SAFETY EVALUATION BY THE OFFICE OF NUCLEAR REACTOR REGULATION

AMENDMENT NO. 22 TO

THE UNIVERSITY OF VIRGINIA

DOCKET NO. 50-62

TABLE 4.1.A Heat Exchanger Secondary Tube Plug Specification

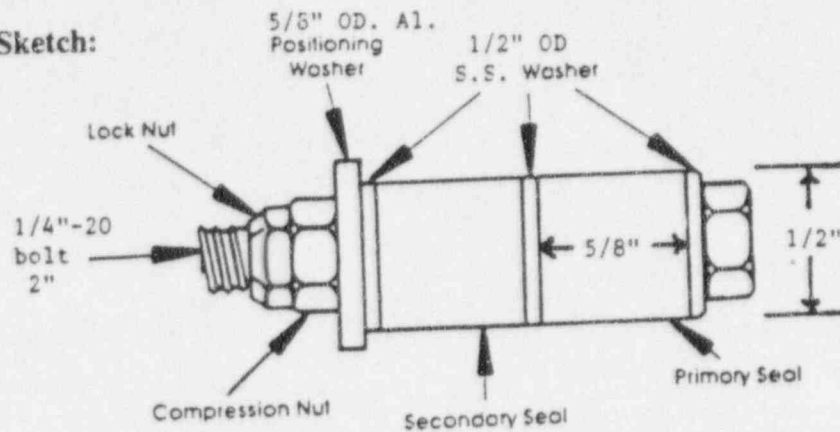
The licensee has submitted a proposed design for a heat exchanger tube plug to be used to seal the heat exchanger secondary tubes that are found to be leaking. The plug specifications are shown in Figure 1. Due to the fact that the proposed plugs will form part of the primary system boundary, the NRC staff has reviewed the plug design, the UVAR staff analysis for installing the plugs, the potential for and consequences of plug failure, and the UVAR heat exchanger primary to secondary leak analysis.

We have reviewed the proposed secondary tube plug design as proposed by the licensee. From a material compatibility standpoint, the proposed plug material should be compatible with the secondary tube material and more importantly, with the tube-sheet support material, which will be an aluminum to aluminum contact point. The expandable/compressible material being made of noreprene or equivalent rubber has been tested under environmental conditions similar or more extreme than those to be present at the UVAR; therefore, no significant degradation is expected. Further, the plug is designed so that a double seal will be accomplished with the installation of a single plug.

Based on our review of the proposed licensee plug design, the proposed procedures for installing the plugs, monitoring heat exchanger pressures, and the commitments by the UVAR staff for performing annual plug inspections, we conclude that the use of the UVAR secondary tube plugs to be acceptable.
